WCS-CISF-16-005

Enclosure 3

**Changed WCS CISF SAR Pages,
Interim Revision 1**

*Figure 1-7
Cask Handling Building Plan*

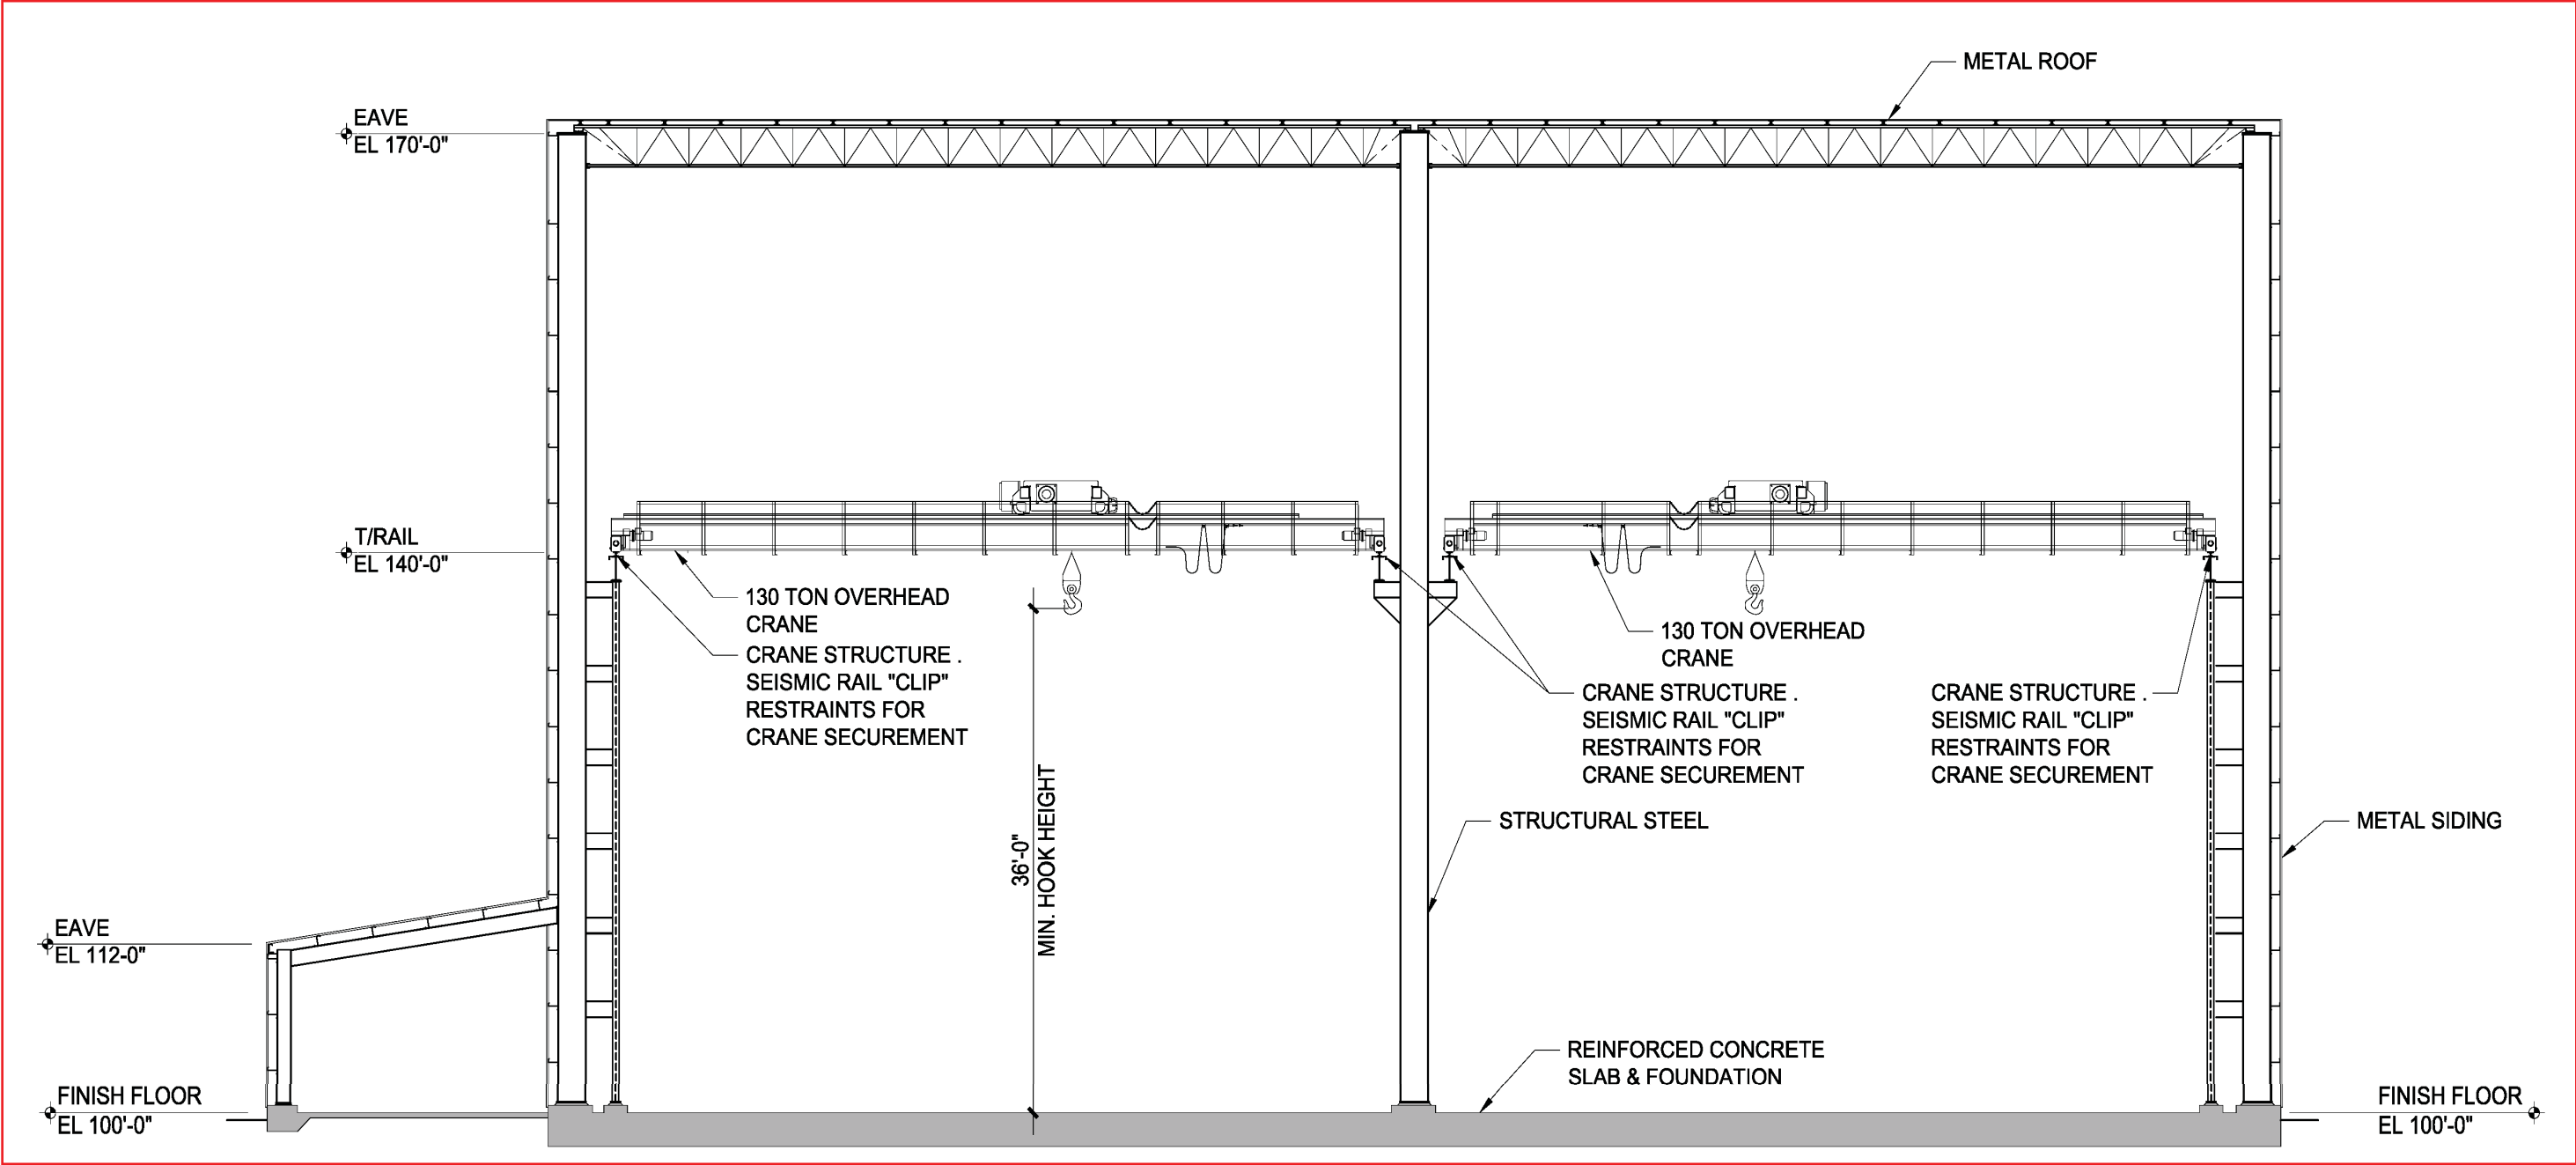
The Cask Handling Building (CHB) is a two-bay ITS - Category C steel structure. The CHB is 140 feet by 130 feet and approximately 70 feet tall with rail access to facilitate cask unloading operations, canister transfer operations, and miscellaneous maintenance activities. Figures 1-7 and 1-8 show the general building layout and building cross section. CHB Structural Design is discussed in Section 7.5.3.

Structural steel beams are provided in the CHB along the crane runways to support the rails for two 130-ton capacity overhead bridge cranes. The steel crane runway support beams are classified as category C Important to Radiological Safety since they provide support for the overhead cranes during a seismic event and prevent the cranes falling onto the transportation cask stations. The steel crane runway support beams are supported on steel columns that are tied to the main structural steel columns of the CHB on one end and steel brackets that protrude from the main structural steel columns of the CHB at the other end. In order to provide lateral support for the steel crane runway support beams, tie members are provided between the steel beams and the CHB frame to resist lateral forces on the steel beams due to crane trolley movement and seismic thrust loads. The steel crane runway support beams are shown in plan on Figure 1-7 and in elevation on Figure 1-8.
